Lehigh Acres Fire Control and Rescue District

May 2, 2024

Reference: Ibis Landing – Proposed T-Intersection
Copperhead Ct N, Lehigh Acres FL

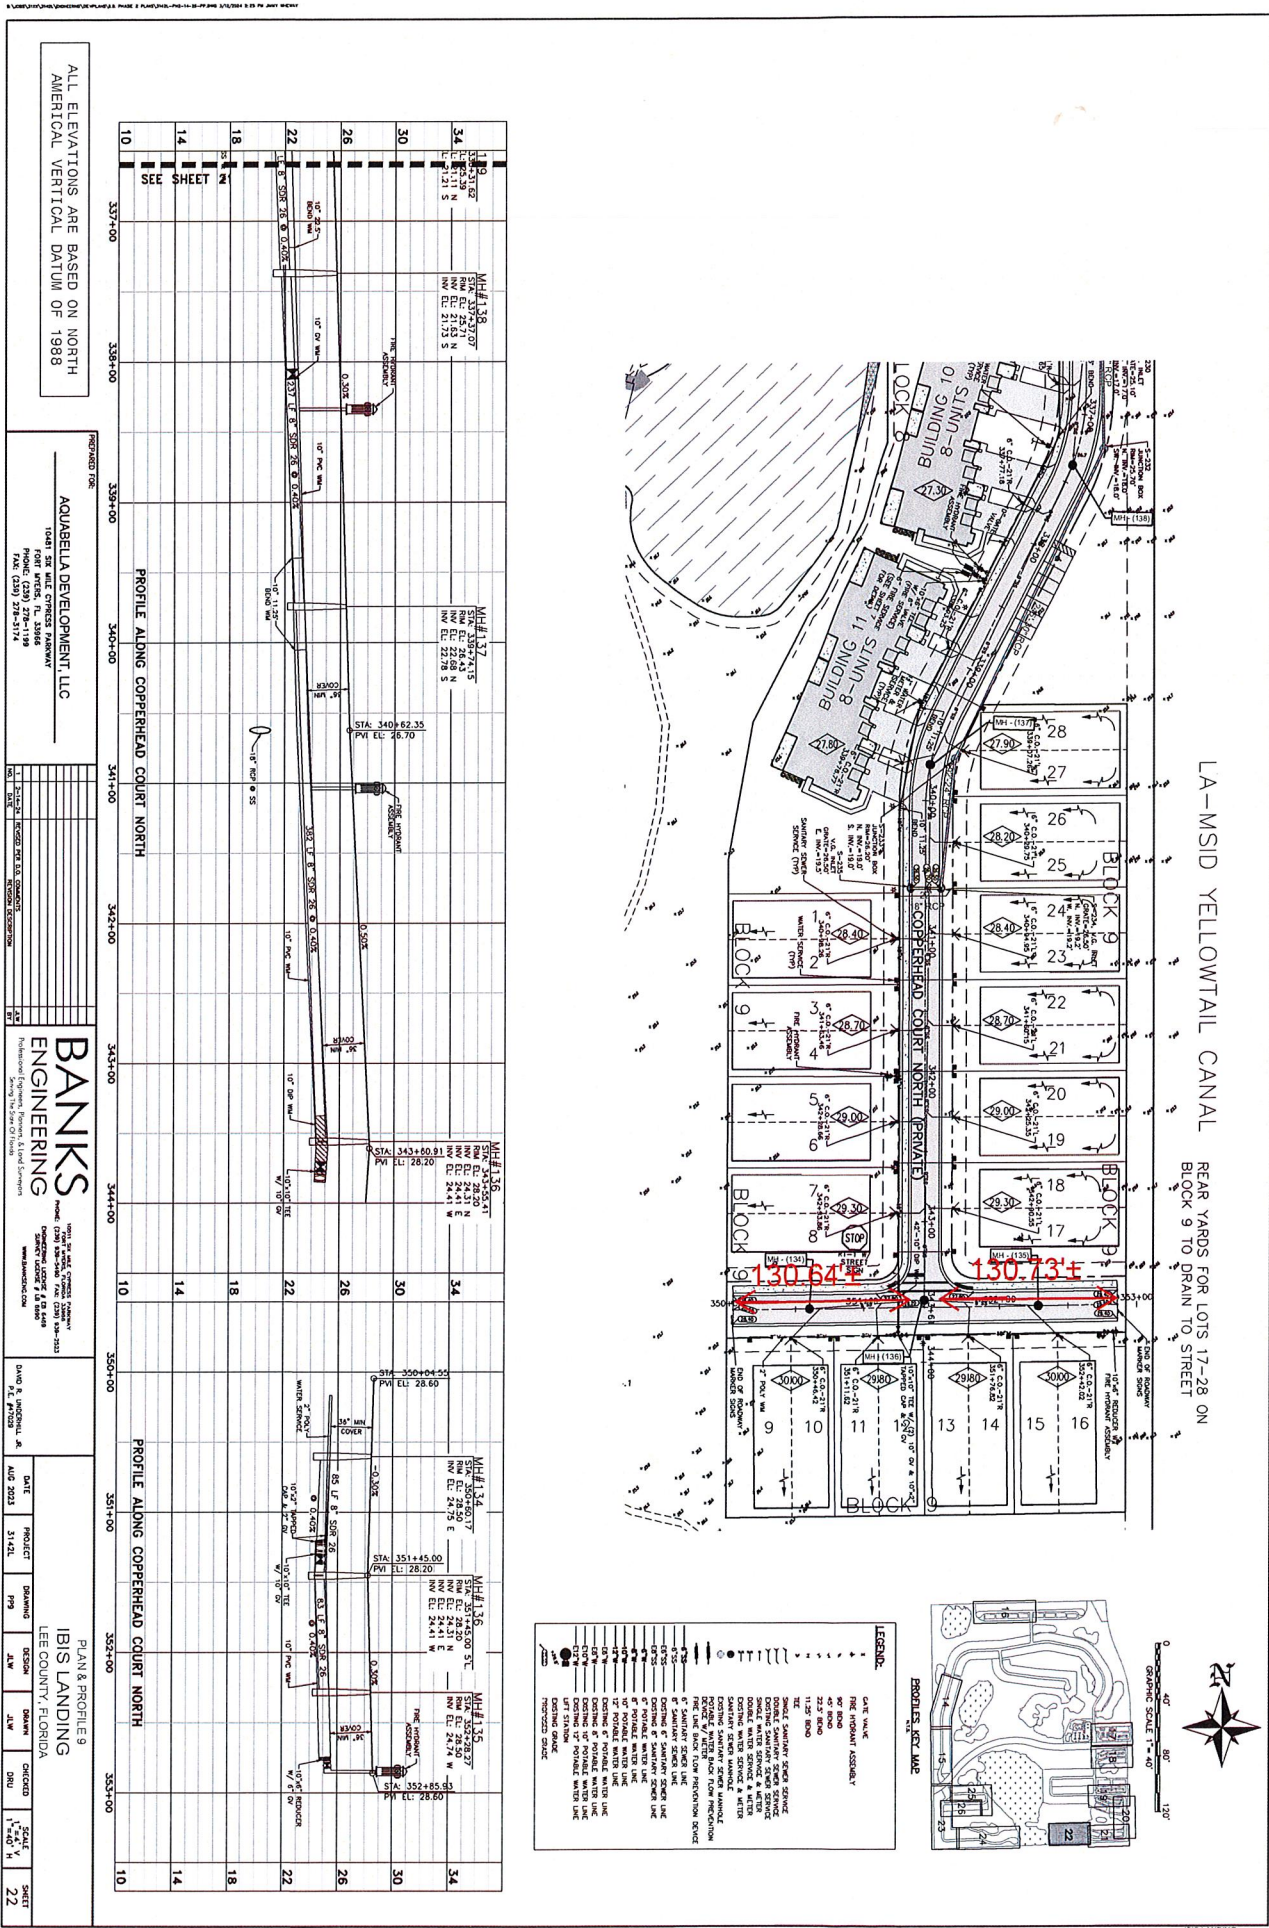
Pursuant to your request, I have reviewed the proposal to provide a t-intersection to allow normal access to residential lots 9-16 of block 9 and for the emergency vehicle access as well (see attached sheets). The fire district does not have any objections to the t-intersection being constructed to allow for the emergency vehicle access and turn around from Copperhead Ct N, as specified.

To ensure that the fire apparatus are able to safely navigate the t-intersection, the fire district would like to stipulate that residential parking not be permitted within the road right-of-way on the east/west portion of the intersection, or the road pavement in front of the lots 9-16 of block 9.

SECTION H-H TYPICAL 40' RIGHT OF WAY ROAD

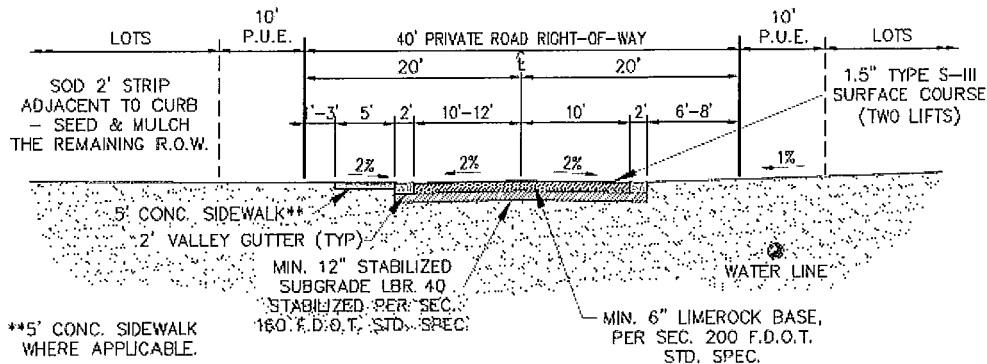
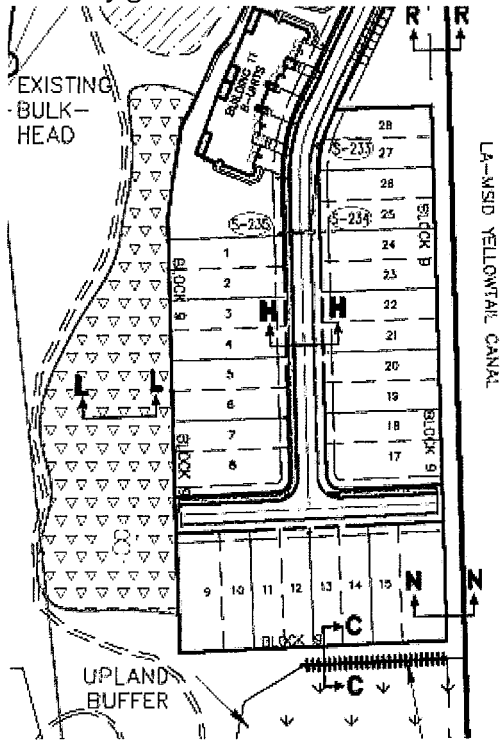
Can you identify what the road width is for the hammerhead intersection? Specifically, the width for Copperhead Ct N at the intersection and the east/west road pavement in front of units 9-16. Thank you for identifying the lengths.

Thanks for getting back to me so quickly! Please see below excerpt from the plans. 10' travel lanes with 2' valley gutter on each side.
